STATE OF WASHINGTON  
DEPARTMENT OF ECOLOGY

Re: Quarterly Notification of Class 1 Modifications to the Hanford Facility Resource Conservation and Recovery Act (RCRA) Permit, Dangerous Waste Portion, (Quarter ending March 31, 2002)

**Hanford Facility RCRA Permit Modification Notification Forms  
Part III, Chapter 2 and Attachment 18  
305-B Storage Facility**

Figure 4-6. Segregated High Bay Drum Storage Areas

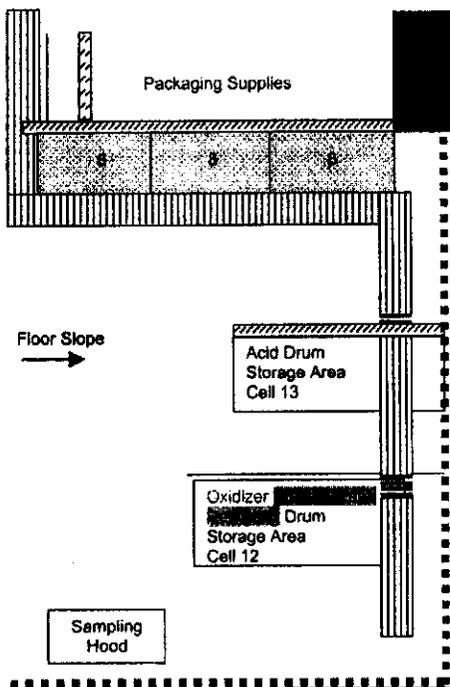
Chapter 4.0, Figure 4-6:

**Figure 4-7. High Bay Storage Area  
(Page 1 of 2)**

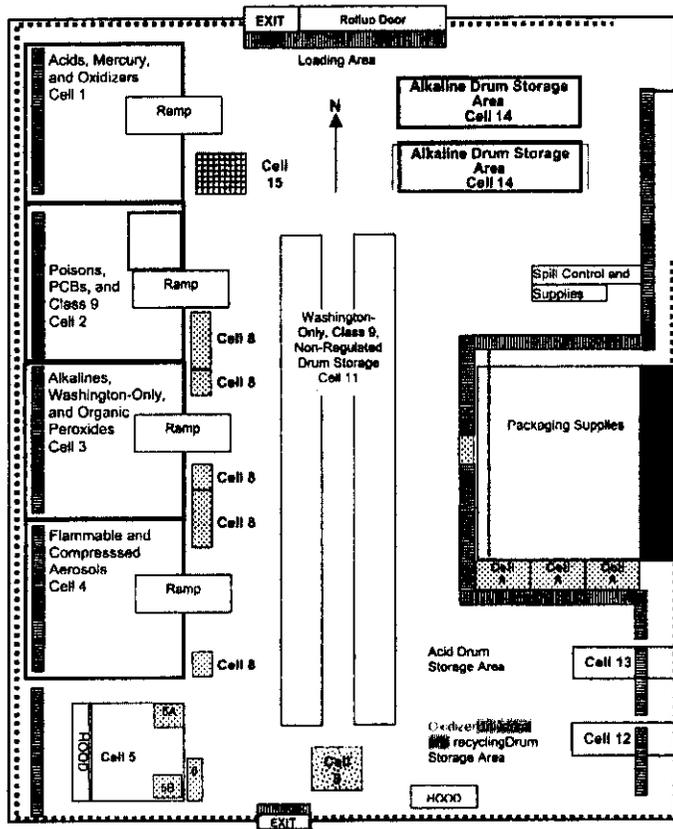
Description of Modification:  
Chapter 4.0, Figure 4-7:
